Office Action Summary

10/691,854

FALAHEE, MARK H.

- 1) ☒ Responsive to communication(s) filed on 13 June 2005.
- 2a) ☒ This action is **FINAL**. 2b) ☐ This action is non-final.
- 3) ☐ Since this application is in condition for allowance except for formal matters, prosecution as to the merits is closed in accordance with the practice under *Ex parte Quayle*, 1935 C.D. 11, 453 O.G. 213.

Fig-6B

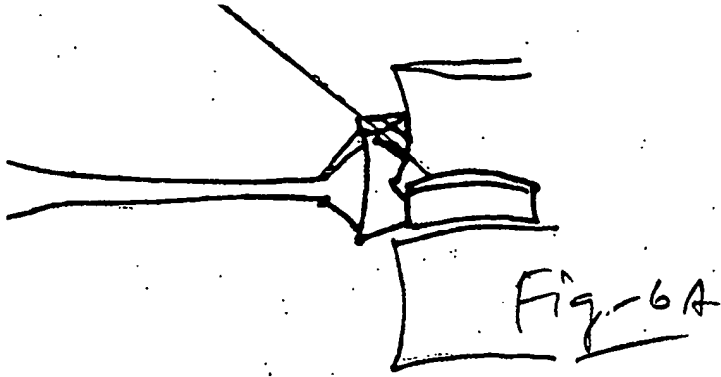
Not
Approved
For
Entry
PBP
8-16-05

Fig - 7A

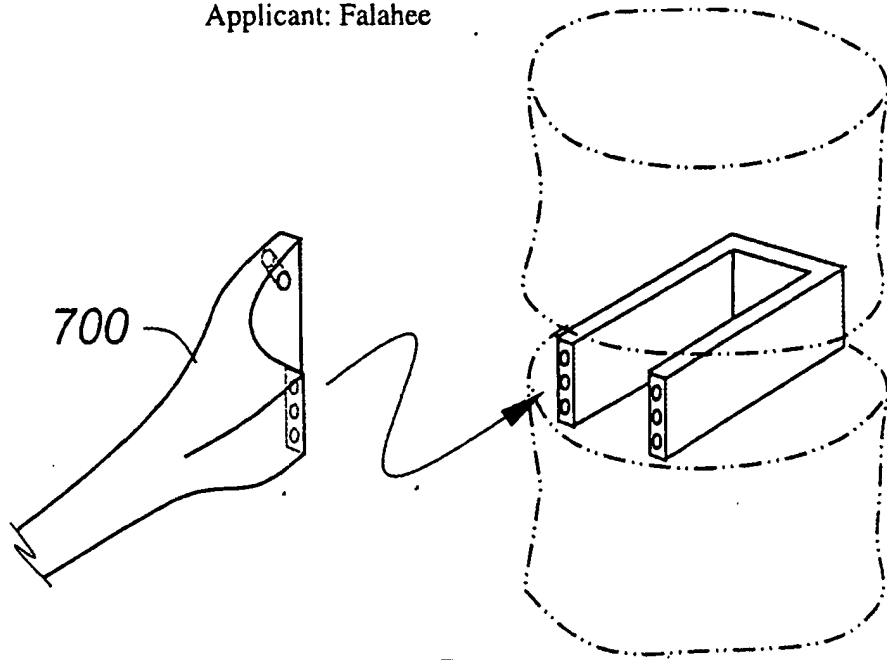
Proposed drawing changes were received on June 13, 2005. The proposed changes were not approved because Figures 7A and 7B attempt to add new matter to the specification. In particular, the detailed features of shape and details of the figures do not appear to have original support from the specification or original drawings. The drawing changes proposed for Figures 9A and 9B are acceptable and would be entered if filed in a separately filed set of proposed drawing changes.

Not
Approved
For
Entry
BP
8-16-05

New corrected drawings in compliance with 37 CFR 1.121(d) are required in this application because the ones filed June 13, 2005 are not acceptable. Applicant is advised to employ the services of a competent patent draftsman outside the Office, as the U.S. Patent and Trademark Office no longer prepares new drawings. The corrected drawings are required in reply to the Office action to avoid abandonment of the application. The requirement for corrected drawings will not be held in abeyance.
